**Historic Area Commission  
Community Room Senior Center  
400 South St., New Castle, DE 19720  
Thursday, June 11, 2026 – 6:30 p.m.**

**AGENDA**

HISTORIC AREA COMMISSION  
New Castle Police Community Room  
1 Municipal Drive  
March 12, 2026

**4. Site Visit (see photographs at end of memorandum)**

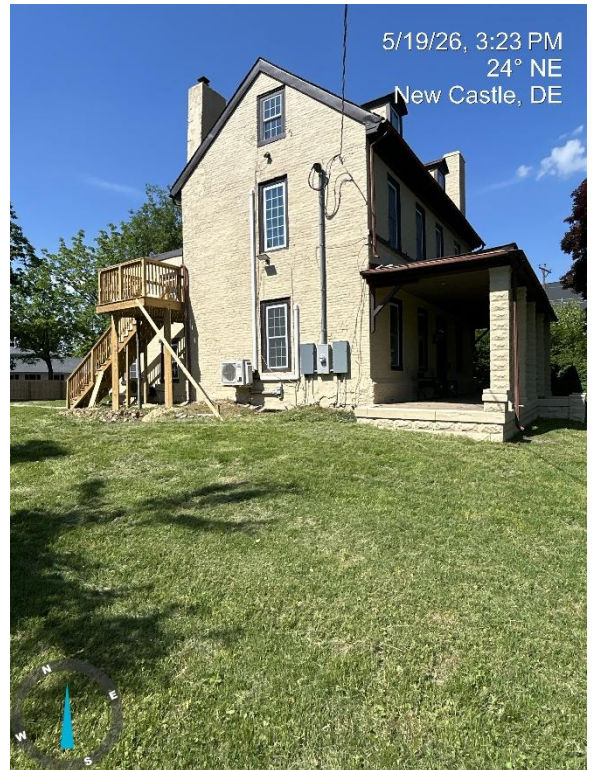
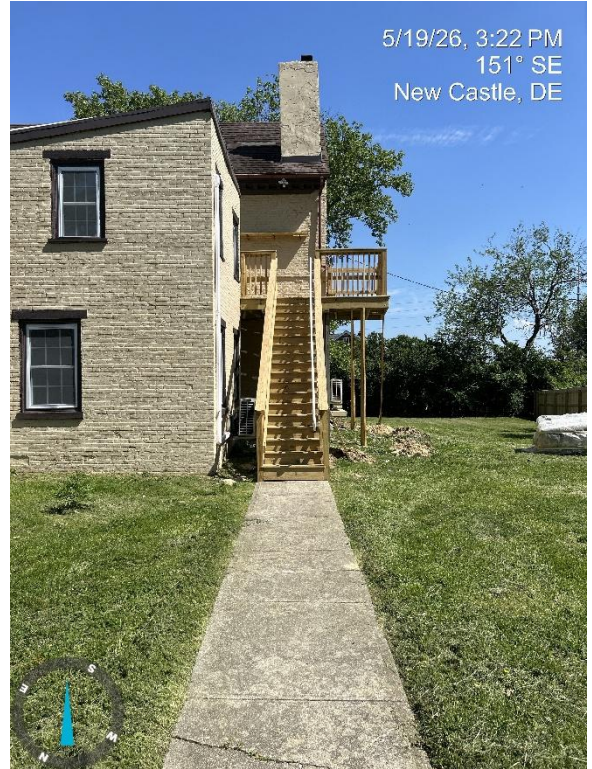
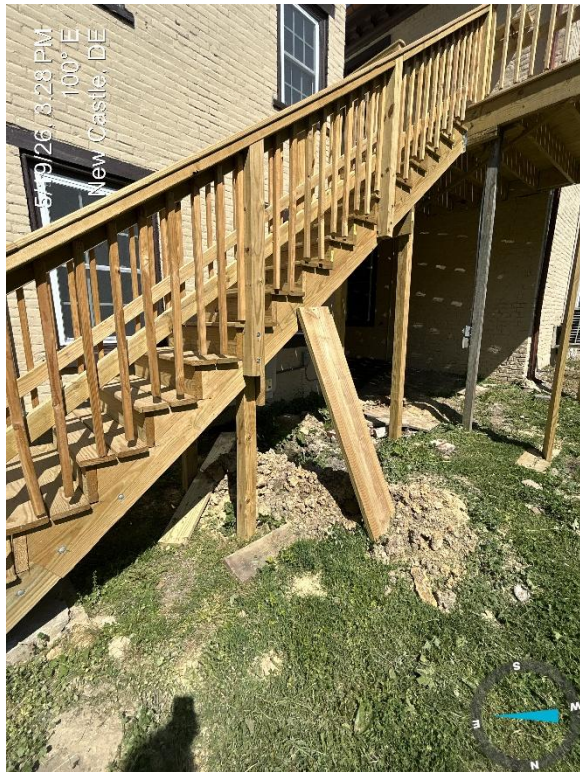
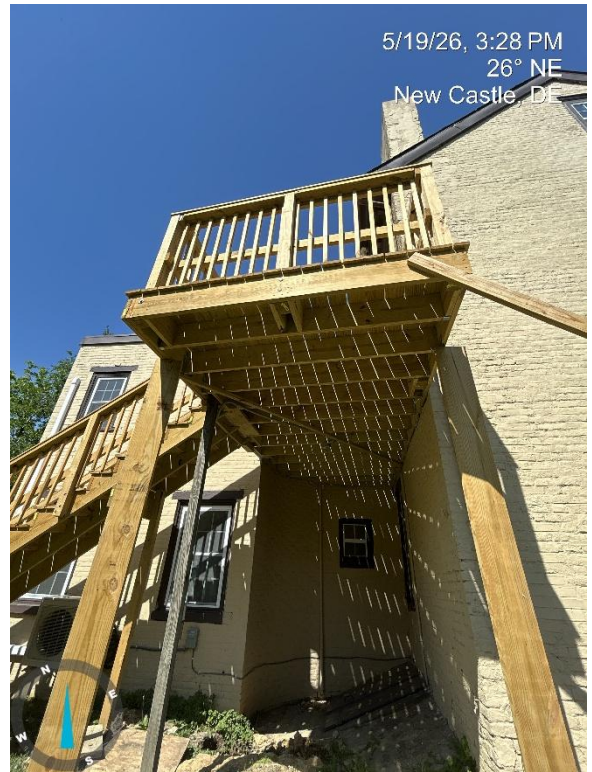
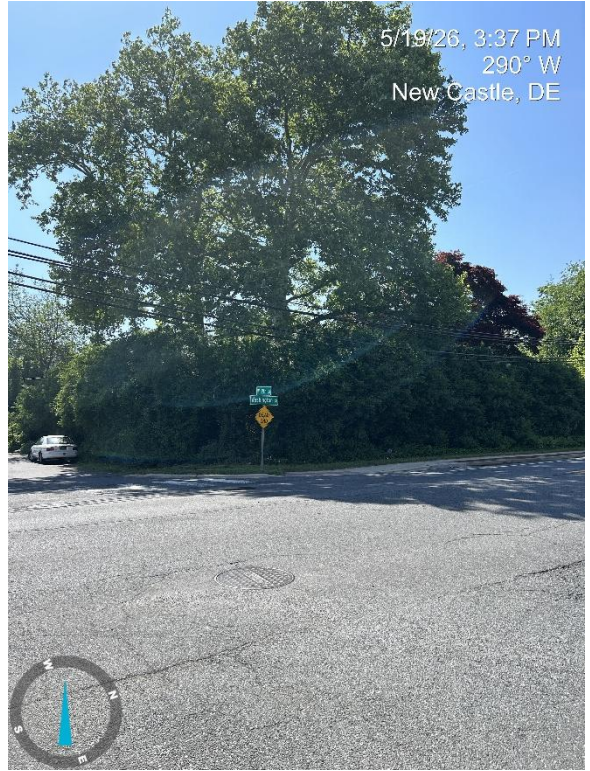
- a) At site visit it is apparent deck was constructed; upon discussion it is stated it was started at least in March of 2026.
- b) Contractor said he was told by phone that Hac review was not required and could not state who said that. Architect notes that Owner had gone through the review process to get the fence approved; their contractor had worked closely with Architect prior to meeting to get concurrence.

- c) There are several design elements that do not comply with HAC Design Guidelines and Standards:
  - i. Deck is pressure treated wood – unfinished lumber is not appropriate.

- d) Building code official notes structural deficiencies and the need for signed and sealed drawings to be submitted.
- e) Architect reiterates the two-tier application process.

- f) Pictures from public right-of-way show limited visibility.
